FirstLine Schools, Inc. Langston Hughes Elementary Classroom Building Addition

July 19, 2023

ADDENDUM NO. 2

1 ELECTRICAL RISER DIAGRAM
Scale: NTS

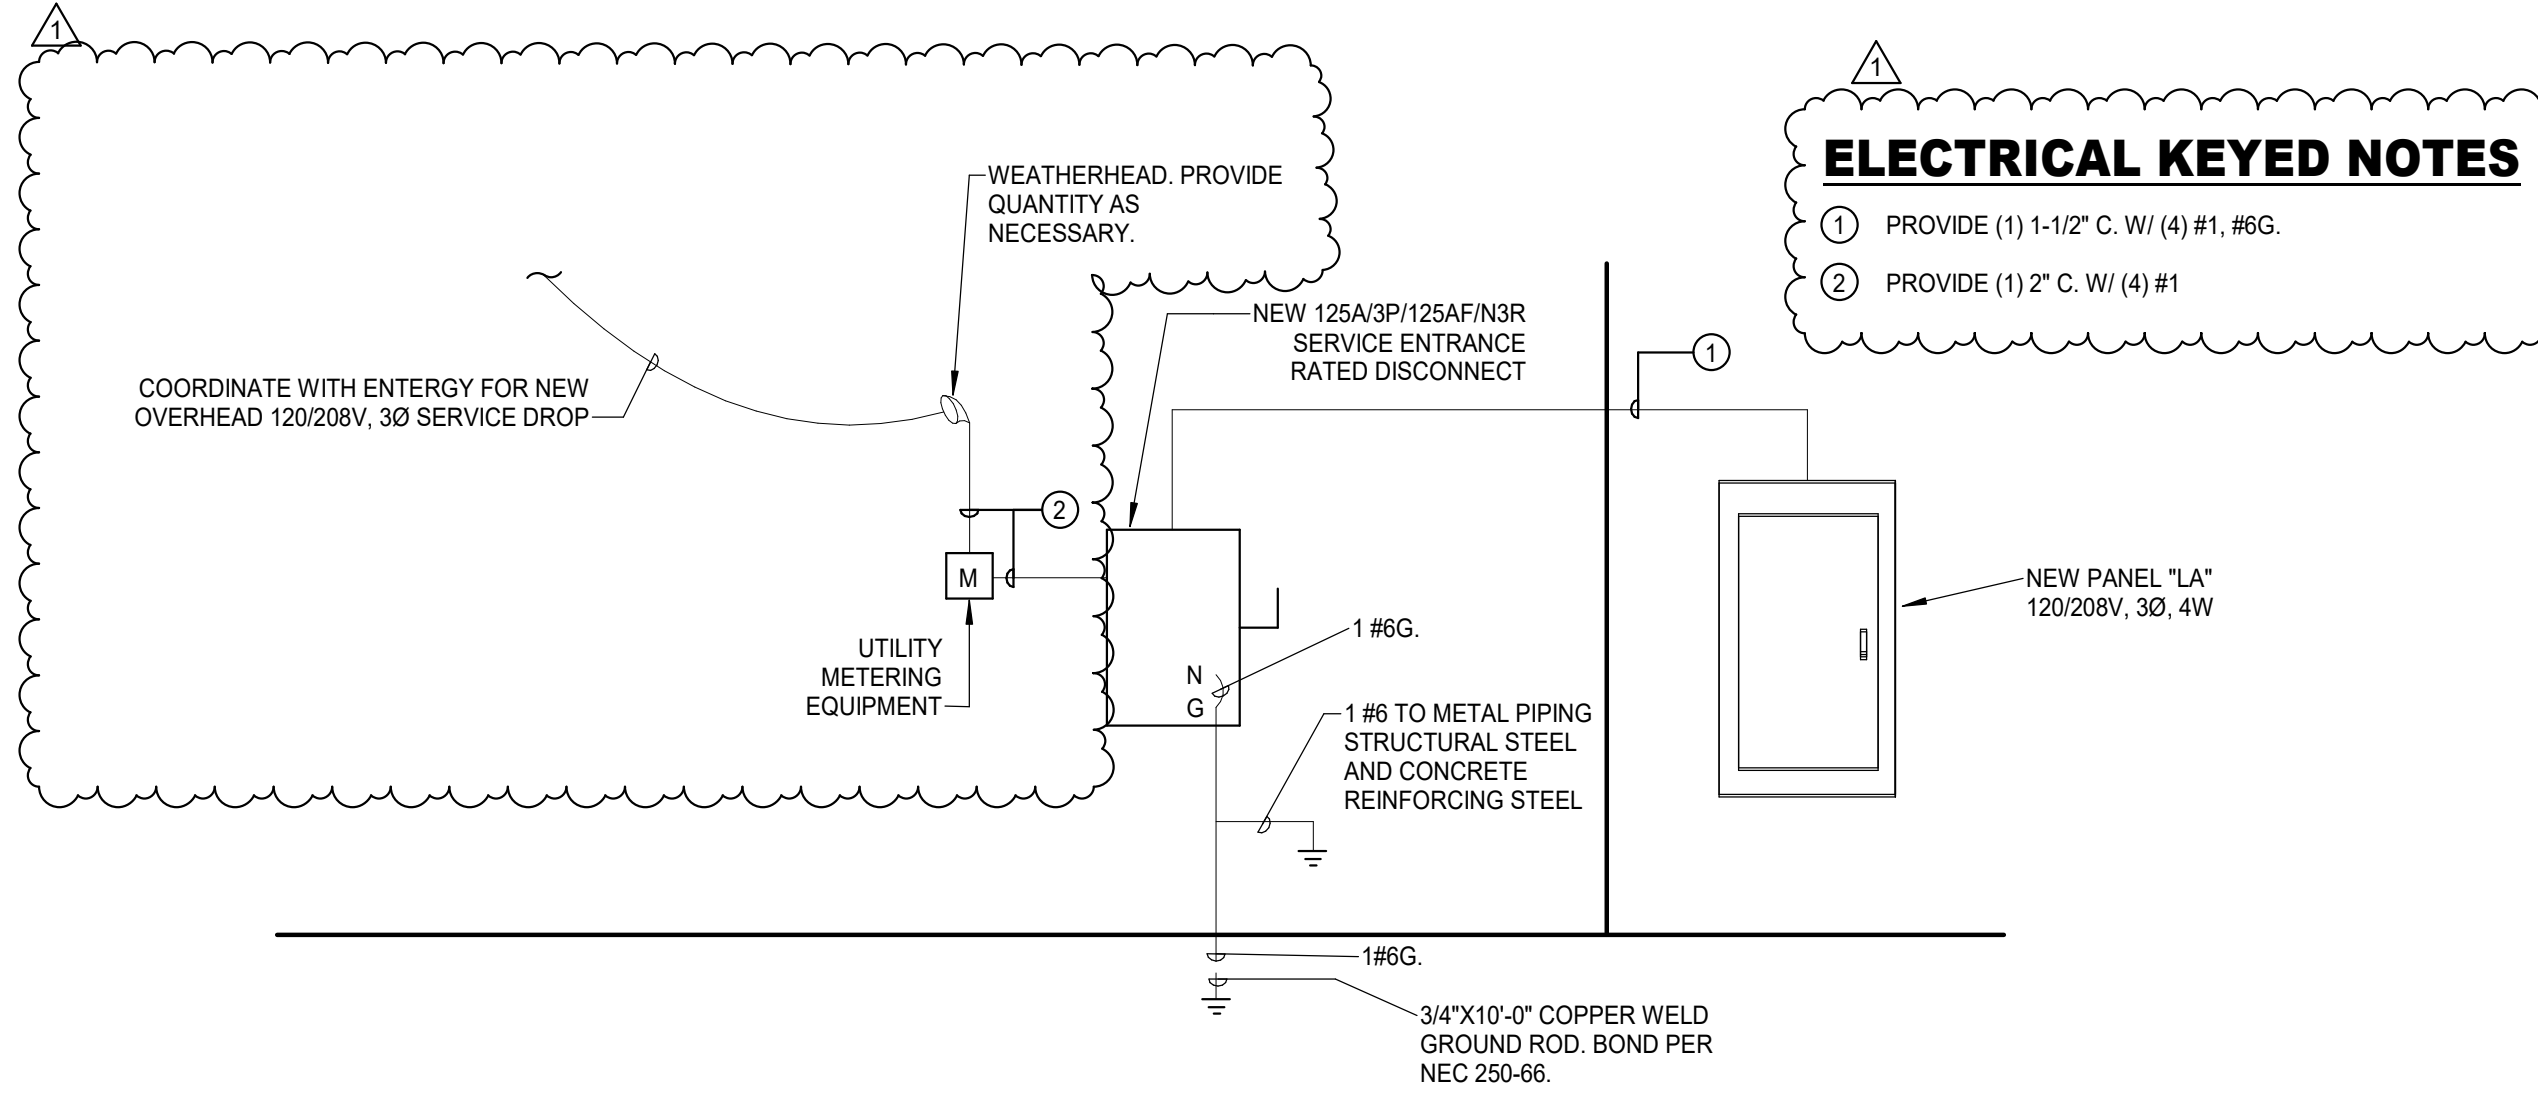
Item No. 4: **REPLACE** the following sheets with the revised sheets included in this addendum:
E001 Electrical Site Plan
E201 Electrical Details
